**CONSTRUCTION COMMITTEE
OCTOBER 19, 2023****SUBJECT: CEQA ADDENDUM FOR THE EAST SAN FERNANDO VALLEY LIGHT RAIL
TRANSIT PROJECT****ACTION: APPROVE RECOMMENDATION****RECOMMENDATION**

EAST SAN FERNANDO VALLEY TRANSIT CORRIDOR

Environmental Impact Report Addendum

Addendum to the Final Environmental Impact Study/Environmental Impact Report (FEIS/EIR)

Figure 1: Typical at Grade Center Platform Station

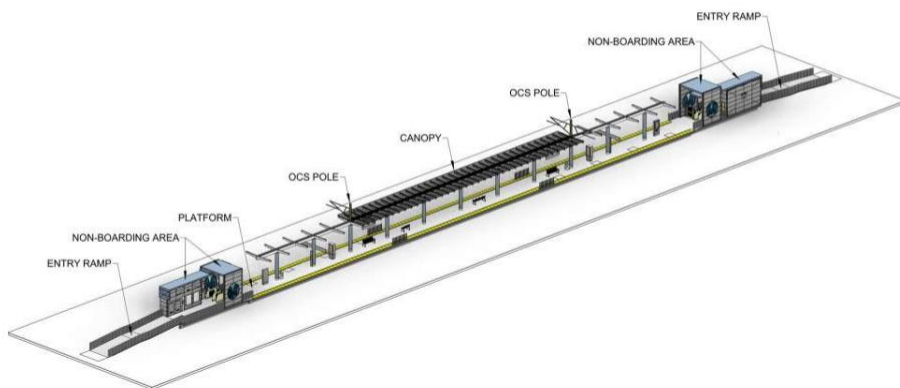
However, due to real estate right of way constraints, LACMTA has identified changes to the following four station locations shown in the Advanced Conceptual Plans dated March 15, 2019:

- < Van Nuys/San Fernando Station was relocated to the middle of Van Nuys Boulevard;
- < Arleta Station was moved from south of Arleta Avenue to north of Arleta Avenue;
- < Woodman Station was moved from south of Woodman Avenue to north of Woodman Avenue;
- < Van Nuys Metro G (Orange) Line Station was relocated to the middle of Van Nuys Boulevard.

All stations, except the Van Nuys/San Fernando, Van Nuys/Metrolink, and Metro G (Orange) Line stations, now include an underground room for electrical, mechanical and systems equipment, due to recent updates to the Metro Rail Design Criteria (MRDC) and Architectural Standard Drawings.

Figure 3: TPSS Site 9 and Nearby Noise-Sensitive Receiver Clusters

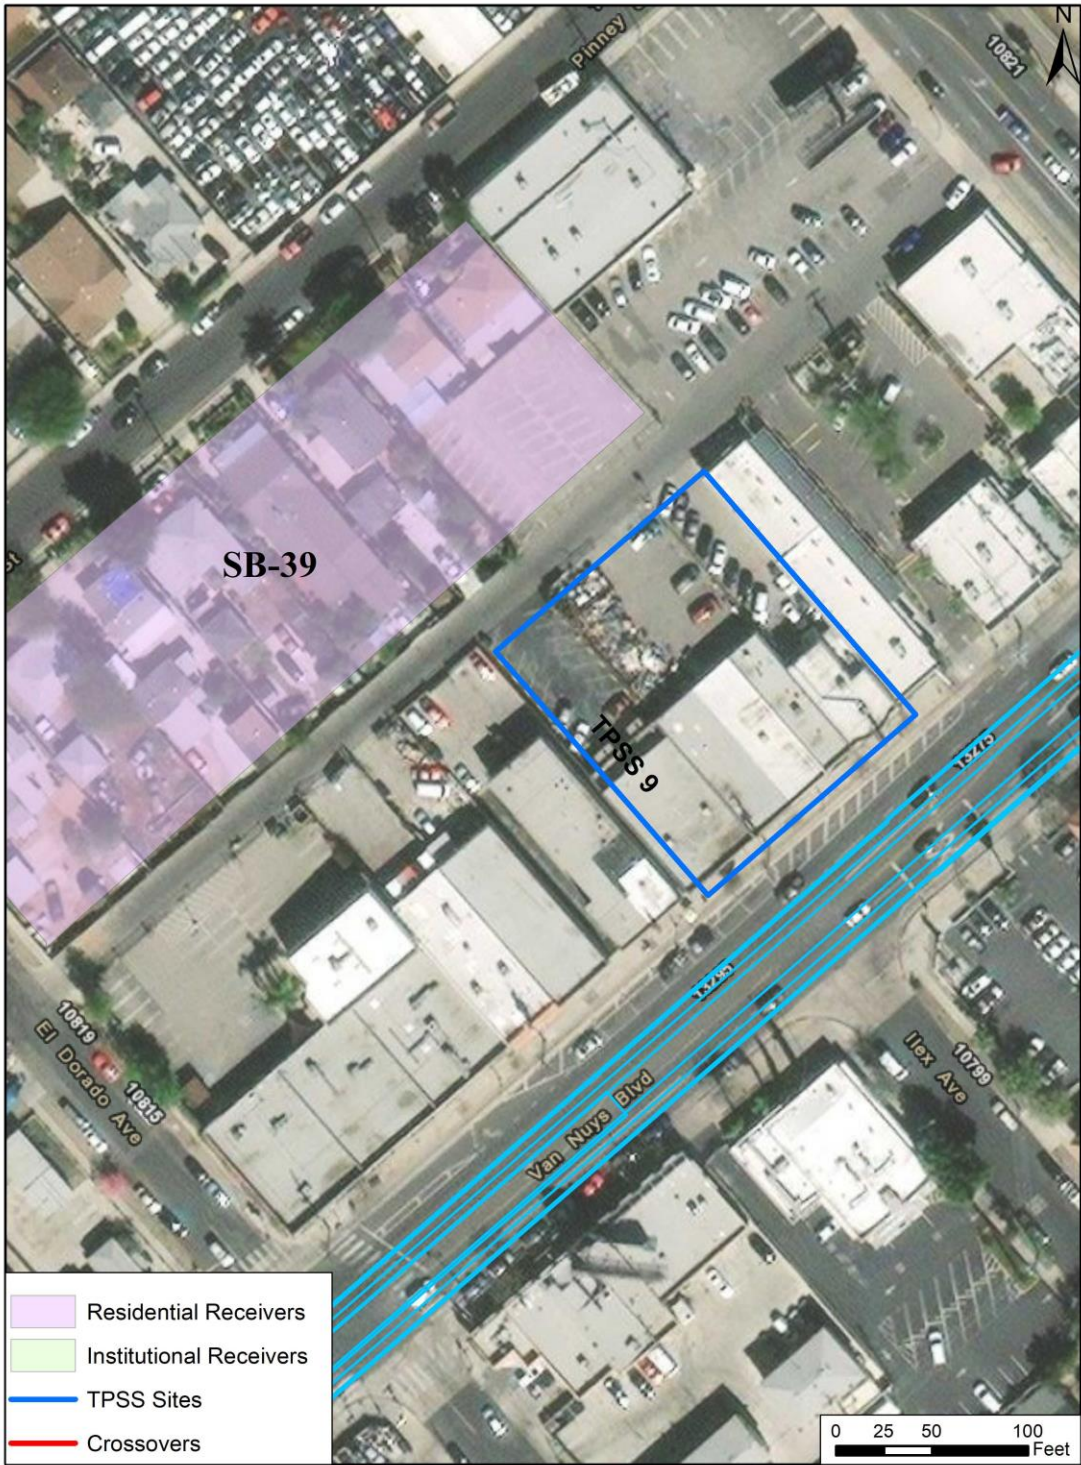
Full property acquisition is also required for TPSS 9 for several buildings on Van Nuys Boulevard between El Dorado Road and San Fernando Road. The existing buildings form a continuous façade that significantly reduces the noise levels at the sensitive receiver cluster ID SB-39, which is set back one row off of Van Nuys Boulevard. The TPSS and other project facilities located at this site would not provide similar noise reduction as the existing buildings, and the removal of the buildings would result in an increase in noise levels above the noise impact threshold. Noise mitigation would be included in the TPSS site design to account for the increase in traffic noise levels from removing the buildings.

Figure 11: Sensitive Receiver Clusters Nearby Crossovers at Parthenia St.

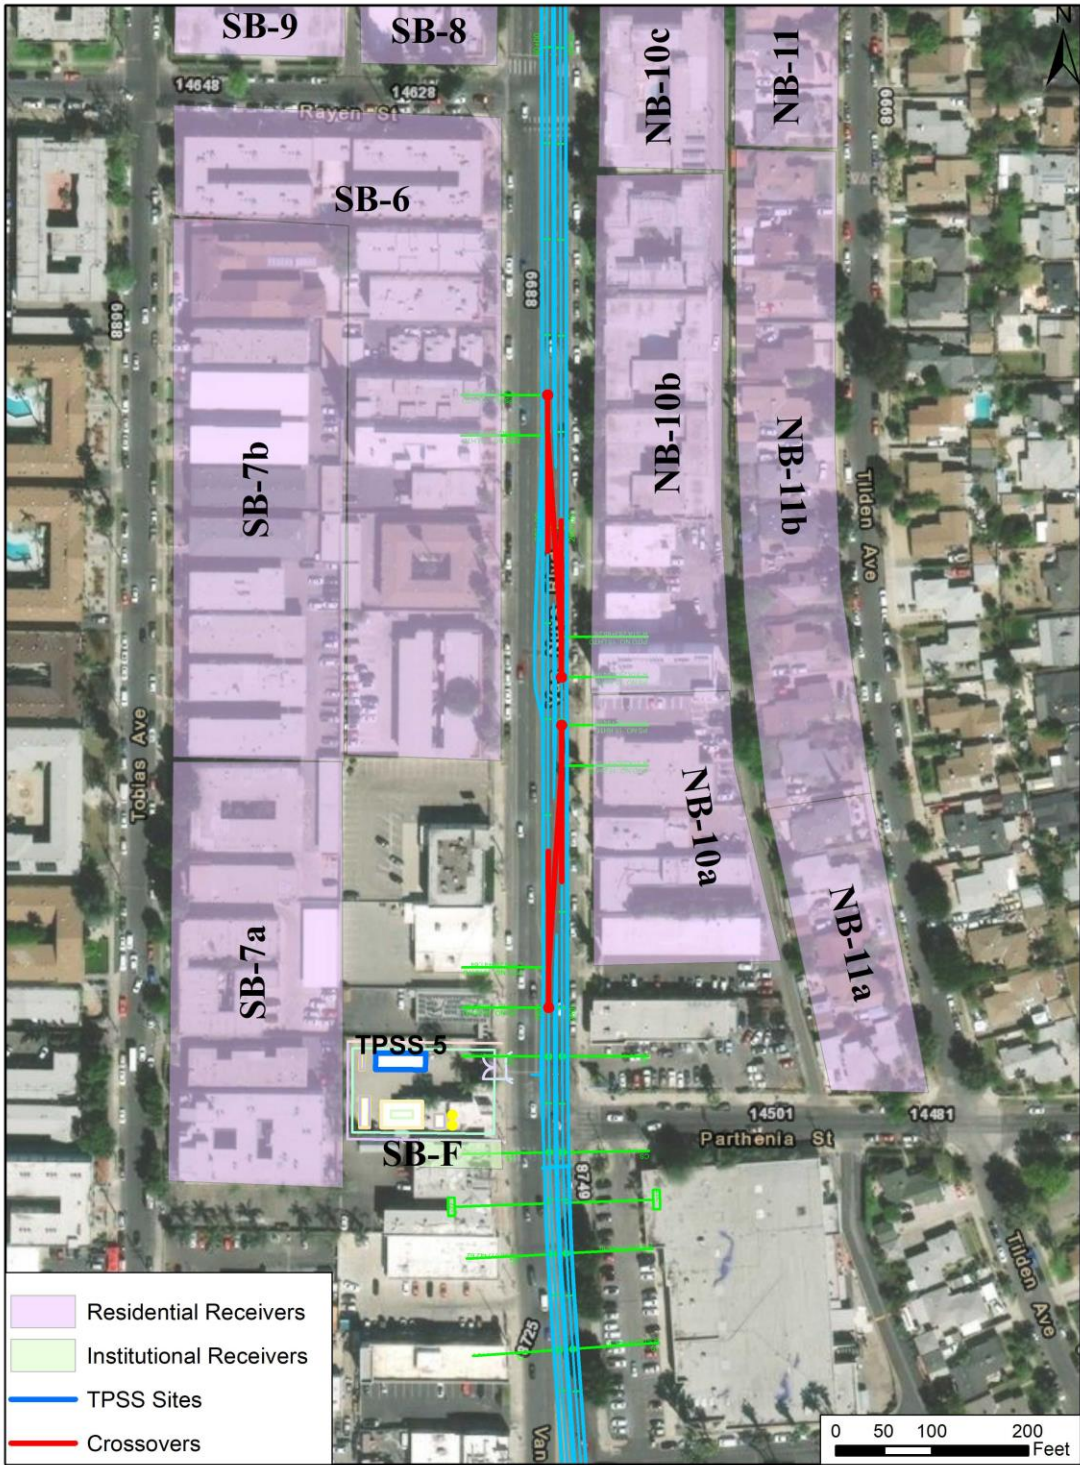
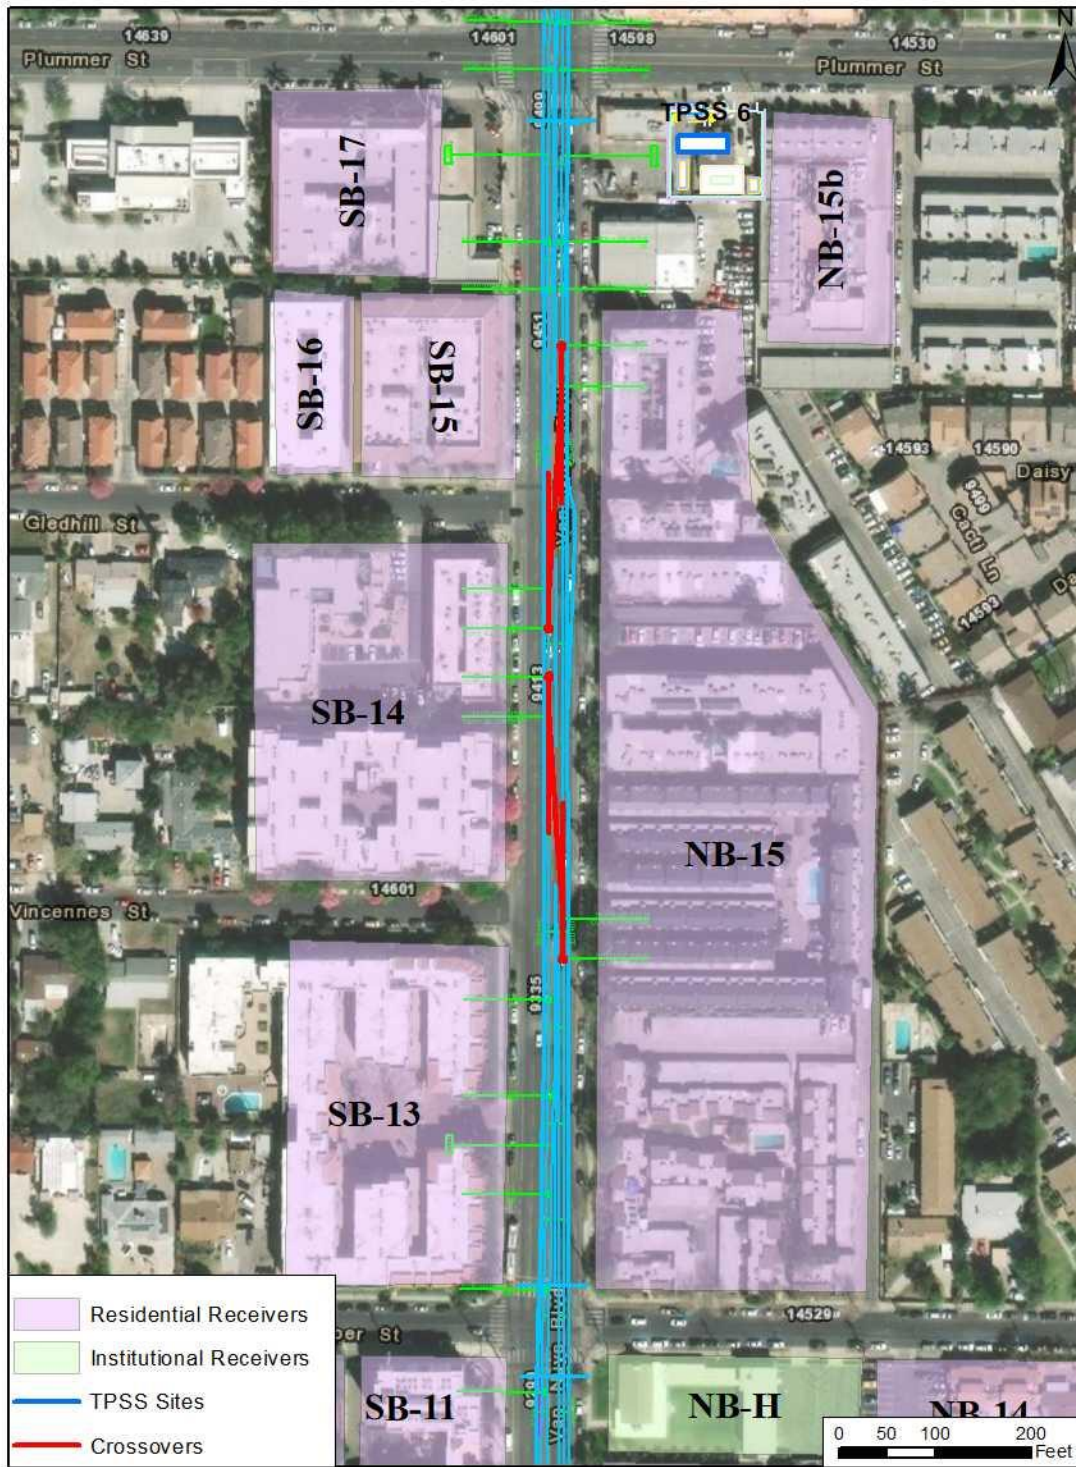
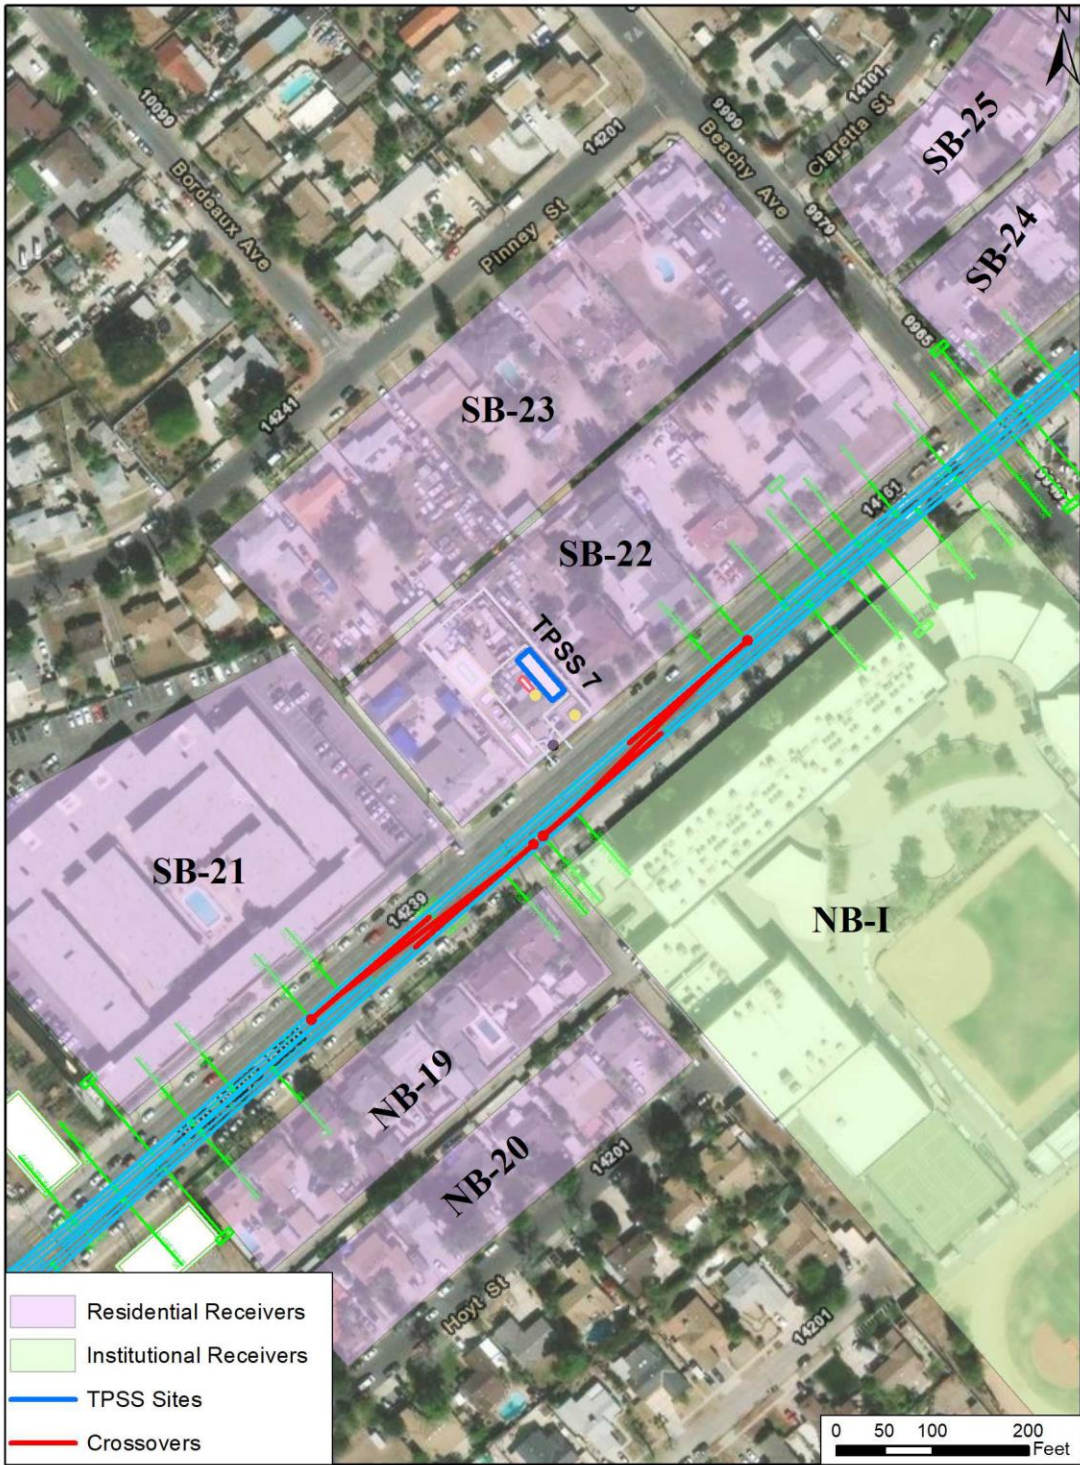
Vibration mitigation measure MM-VIB-2 b would be updated to “~~Fail~~ e c o n t frogs at the crossovers on Van Nuys Boulevard/Parthenia Street, Van Nuys Boulevard/Gledhill Street and Van Nuys Boulevard/Beachy Street. Like moveable point frogs, spring rail frogs provide a continuous running surface in the mainline direction and are therefore expected to provide similar noise and vibration reduction. However moveable point frogs require additional switch equipment that is unlikely to fit in the right-of-way. If further investigation confirms that an alternative low-impact frog would reduce noise and vibration levels below the applicable thresholds, such as conformal frogs, the alternative may be i n s t a l l e d . ”
